RESPONSE LETTER NO. 2 TO REQUEST FOR INFORMATION

Project Title: **Roadway Improvements NW 107 Ave from NW 138 St to NW 170 St.**
Project No.: **20250046 (Capital)**

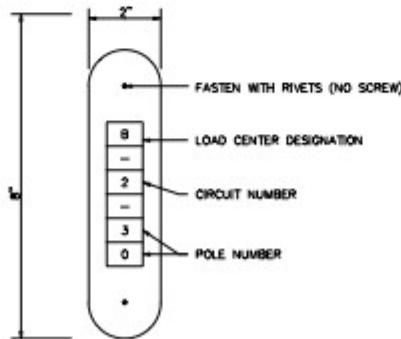
QUESTION: 2) Please clarify what is to be included in note 28:
What does the additional 20% Pole Assemble include:
We assume the following

- Pole
- Arm
- Fixture

But it could also be:

- Just the pole
- And or
- Concrete base
- And or
- MG Squared Pole cable distribution

RESPONSE: 2) Pole, Arm and Fixture.

POLE IDENTIFICATION TAG DETAIL

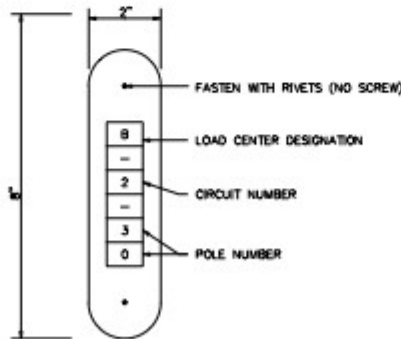
2-Please clarify what is to be included in note 28:
